APPLICATION AND AGREEMENT

TO WAIVE CERTAIN PROVISIONS OF THE PLUMBING CODE

APPLICATION FOR PRIVATE SEWAGE DISPOSAL PERMIT

Subject: Replacement System Variance, Tierney property, Route 105, Togus Pond, Augusta

Site Plan — Scale 1" = [illegible] Ft. or 1" = 50'

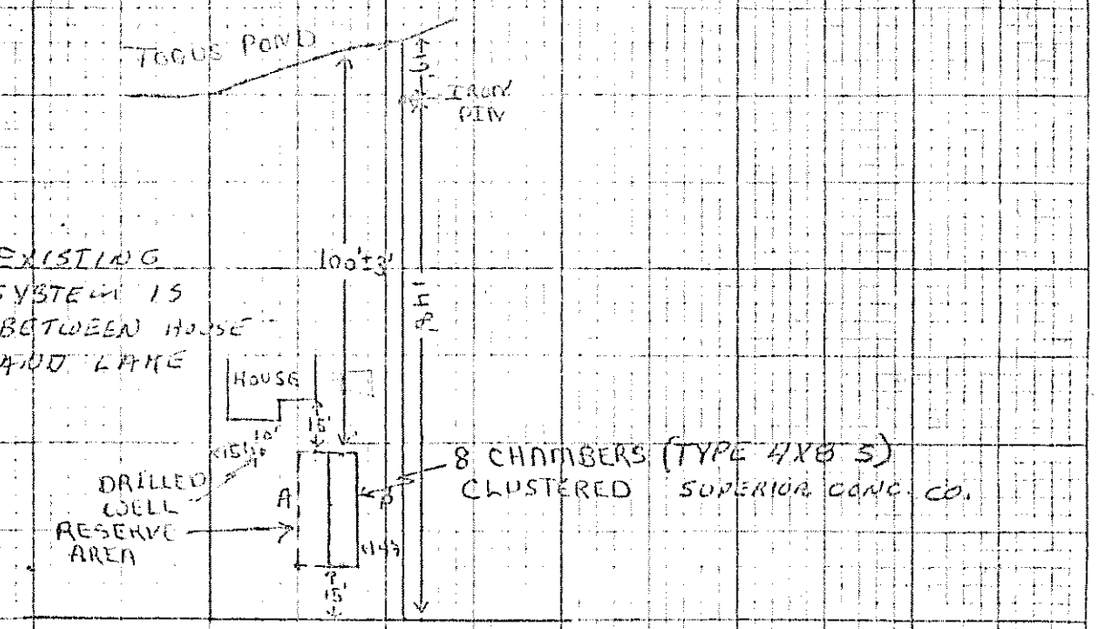
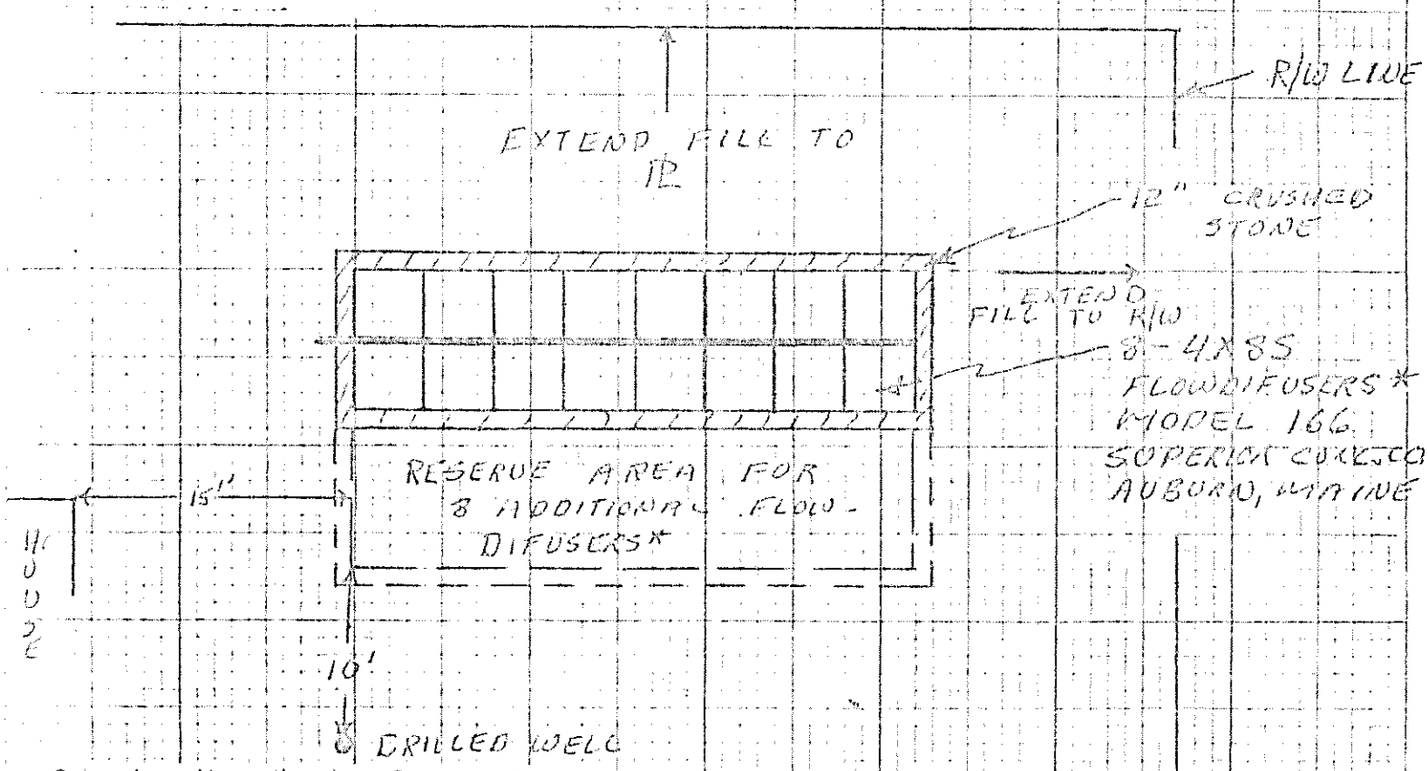
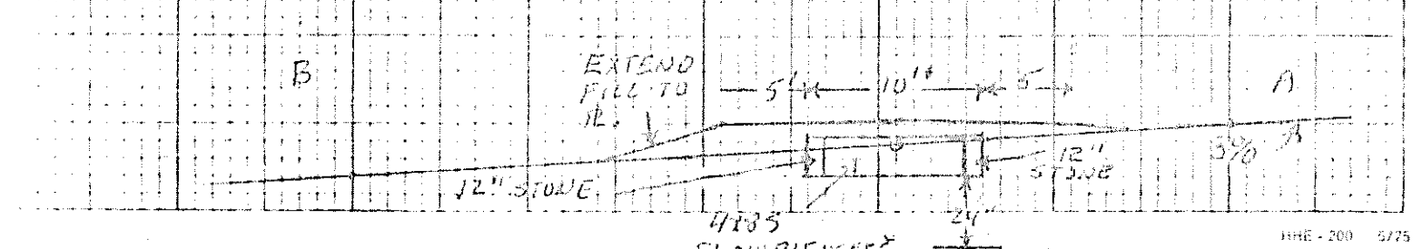
Section of Code to be waived.	Description of specific waiver
1. T-9-1	INSTALL 8 TYPE "F" CHAMBERS ON 2-C SOIL
2. T-4	REDUCE WELL - SYSTEM DIST. TO 10'
3. T-4	" DWELLING - SYSTEM DIST TO 15'

I (~~do~~), (~~do not~~ DO NOT) recommend the issuance of a special permit for the installation as described above.

As indicated to you, due to the reduction in separation distance from the proposed system to two neighboring wells, this office would not be able to grant the variance request although one neighbor has agreed to sign a release form, the second neighbor whose property is presently up for sale, has not indicated approval for the reduction and this would create a legal problem with this office granting a variance. Since the proposed system would be closer to his well than the existing system and also slightly upslope, for this reason it was decided that the best course of action at this time would be to continue with the present system and to conserve water usage as much as possible.

1] Explore potential for an easement to land across Route 105 to a vacant lot, however this would require crossing a major road and the lot across the street may have problems with shallow bedrock soils;
2] Approach the new neighbors if property is sold in hopes of obtaining release form for reduction in well setback;
3] Installation of a holding tank to service the structure. However, this is an expensive proposition and would only be considered as a last possible alternative by this office.

The final alternative short of installation of a holding tank would be the installation of a disposal system to the rear of the property. This alternative would only be considered if the present system proves to be a bad malfunction and a release form still cannot be obtained for a reduction in the setback distance to the neighboring wells. Before this alternative would receive final approval, this office would probably want to visit the property at least one more time.
